## ADDENDUM #1

Reference: Utah National Guard – American Fork Armory  
Window Air Conditioning Units and Boiler Replacement  
DFCM Project No. 06142470

Project Name: Utah National Guard  
American Fork Armory

Addendum No.: 1

SHEET TITLE  
**MAIN FLOOR PLAN**  
SHEET NO.  
**ME101a**

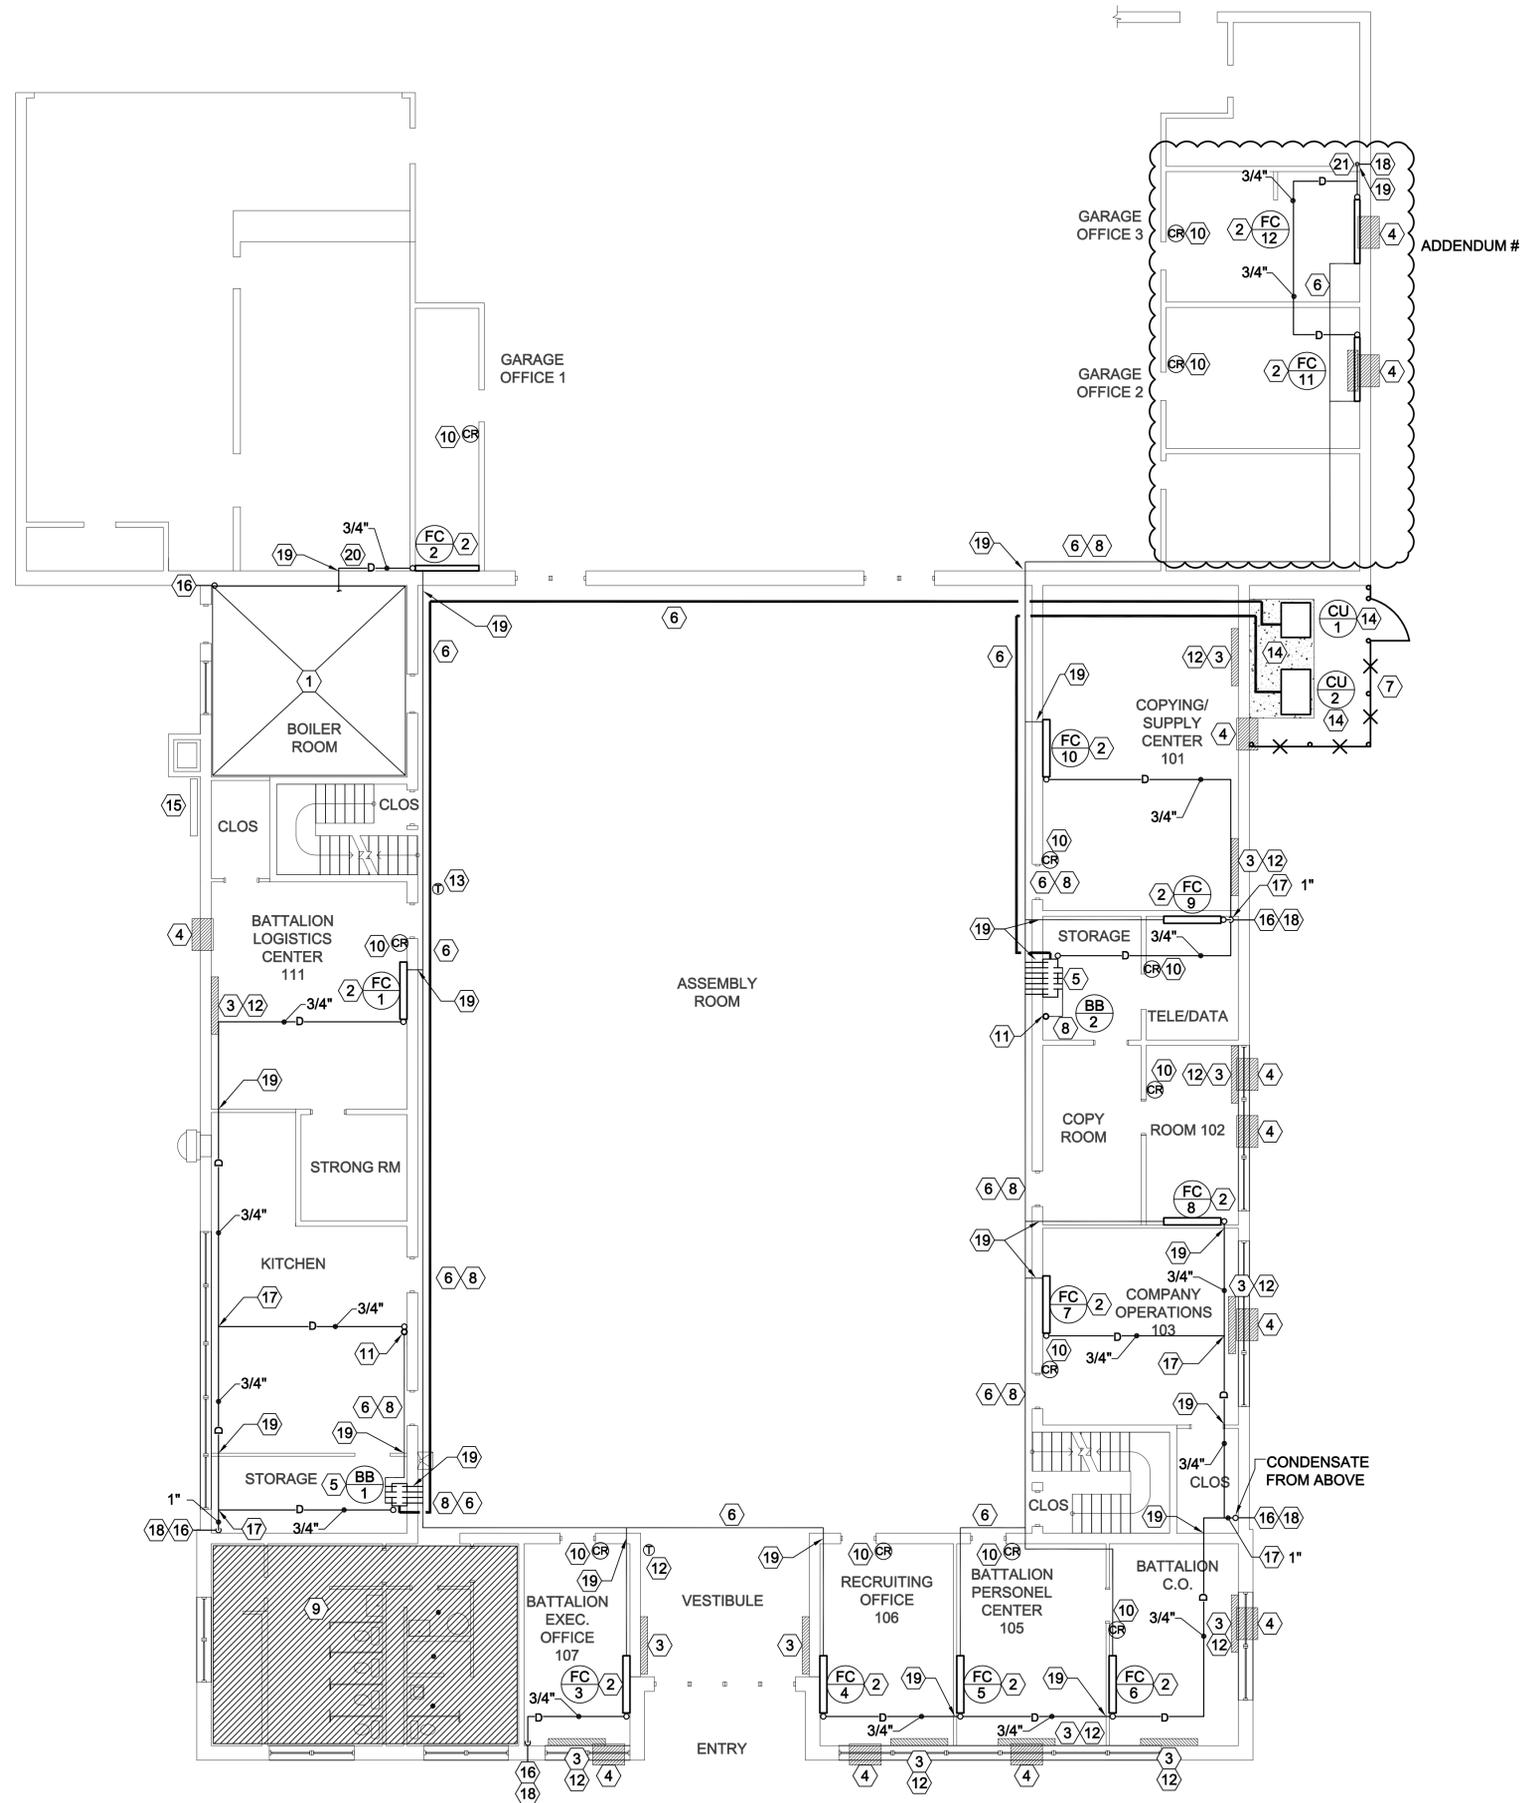
**Item VI-1.** Drawing ME101a - Issued new drawing with the following changes:

1. Relocate fan coil unit FC-11 from storage room to garage office #2.
2. Provide new fan coil unit FC-12 with all refrigerant piping, electrical, etc. in garage office #3.
3. Combine drain lines from FC-11 and FC-12 and route to storage room, drop down in storage room, core drill through outside. Seal air and water tight.
4. Added note 21 - "Drop 3/4" drain line in storage room and route to exterior."
5. Under general notes, change note #1 to read, "Where refrigerant piping is exposed under the balcony and other areas, provide a sheet metal covering attached to the deck. Paint same color as walls.
6. Add note #3 under general notes. Note #3 shall read, "Locate the main centralized controller for new fan coil units in the boiler room. Coordinate location with owner."

**HEAT PUMP SPLIT SYSTEM**  
**SCHEMATIC**

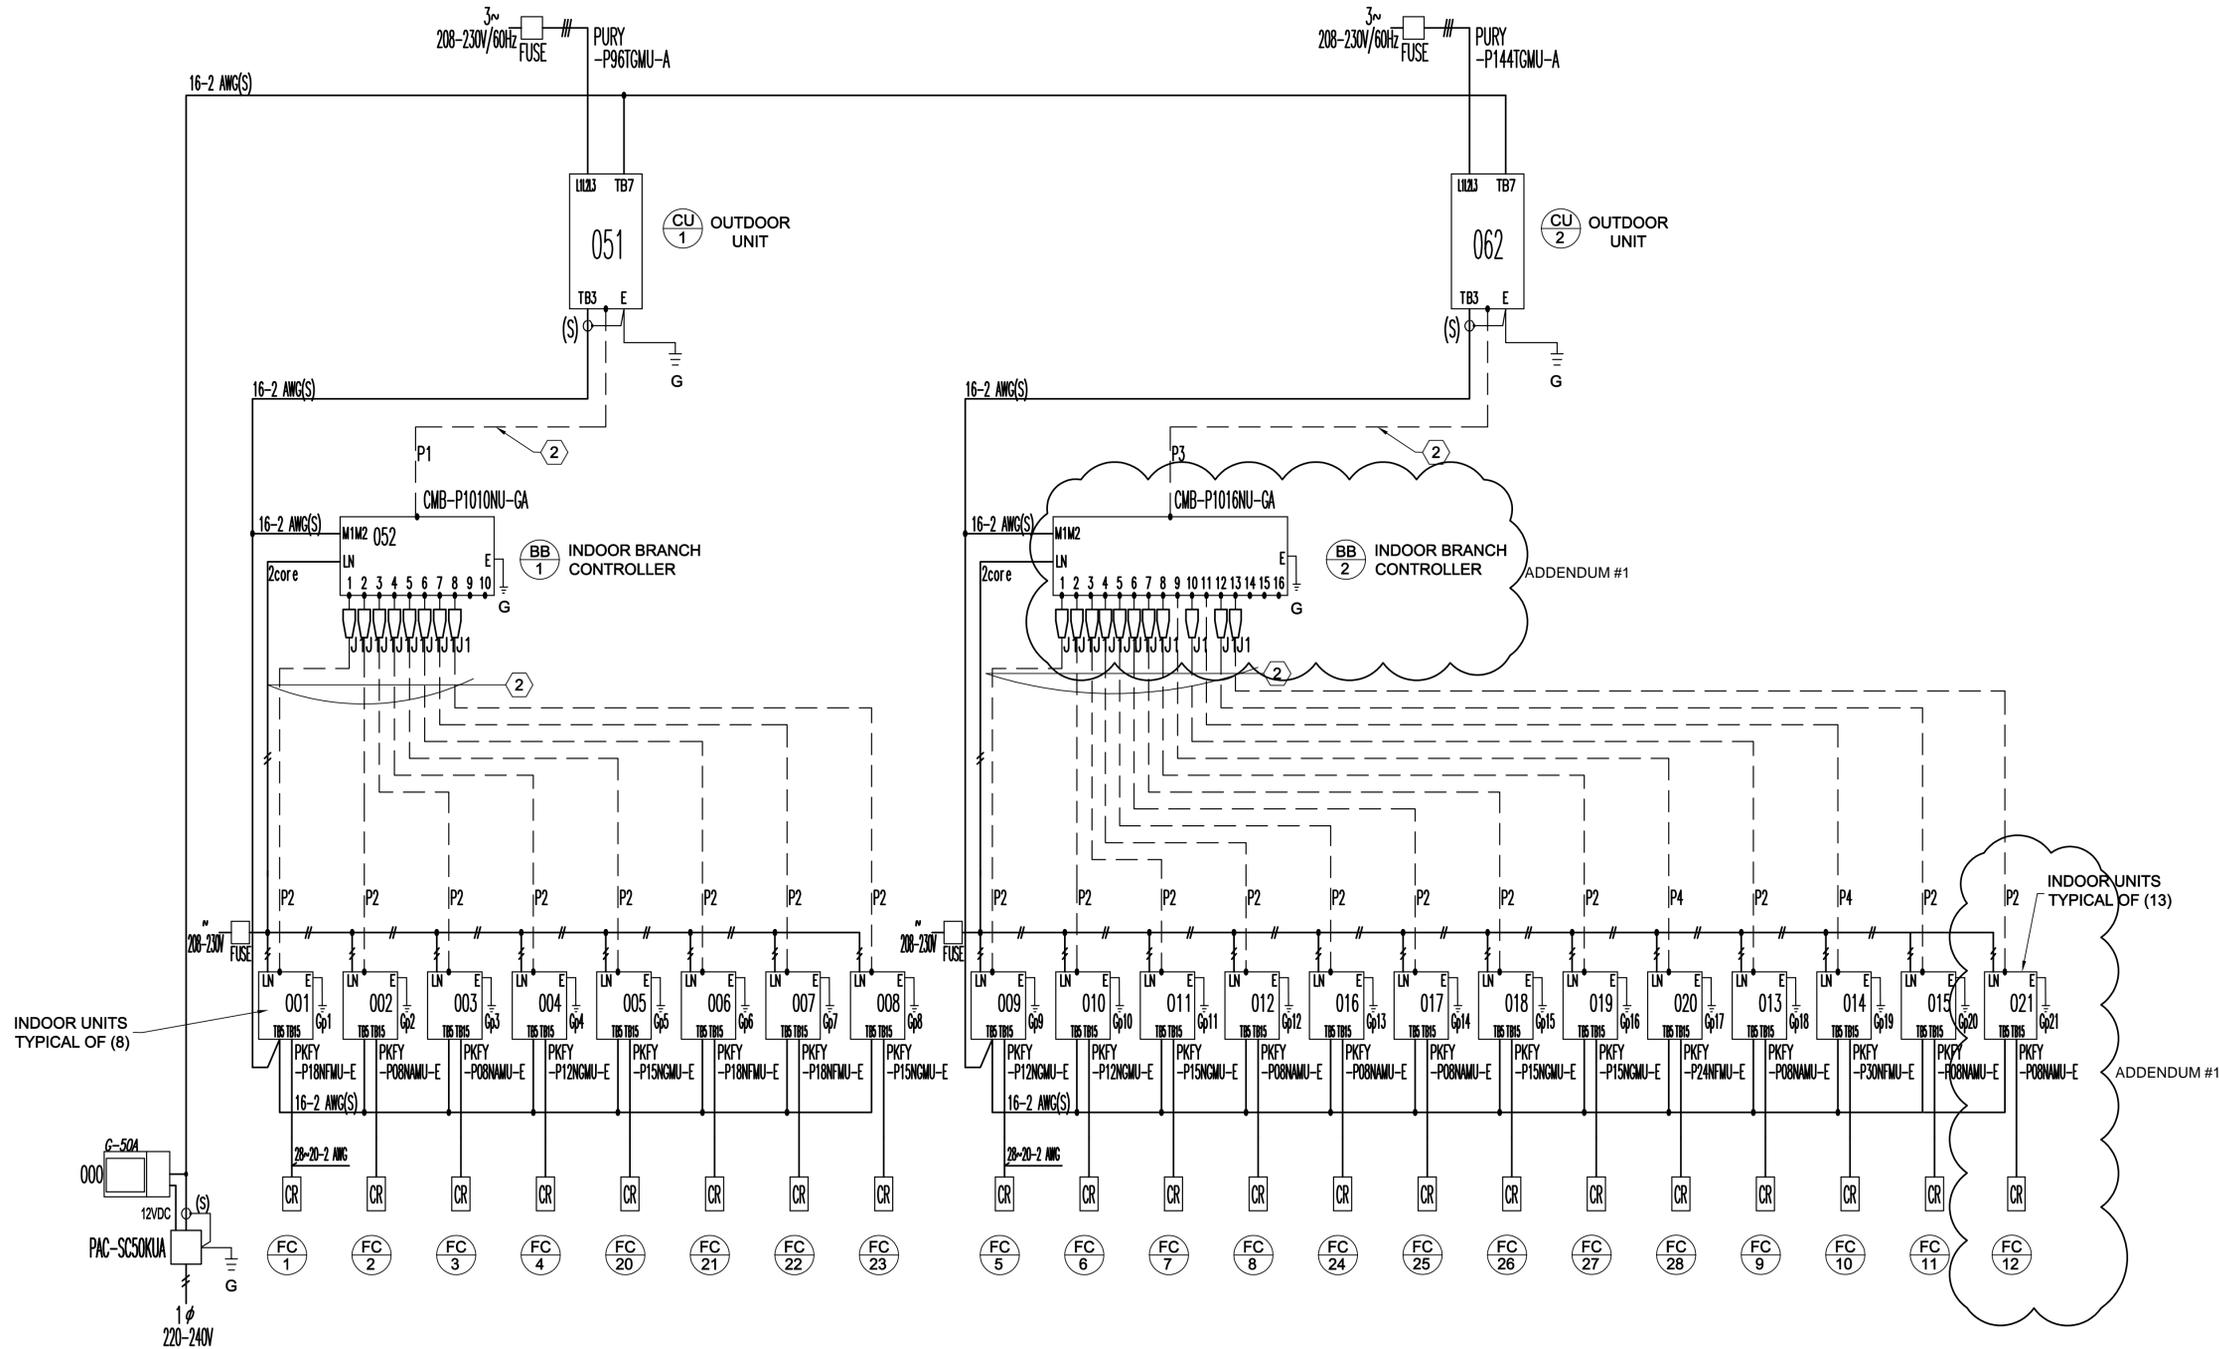
**Item VI-3.** Drawing ME702a - Issued new drawing with the following changes:

1. Replace BB-2 from a CMB-P1013NU-G to a model CMB-P1016NU-G.
2. Added new fan coil FC-12 with all associated piping, controls, electrical, etc.
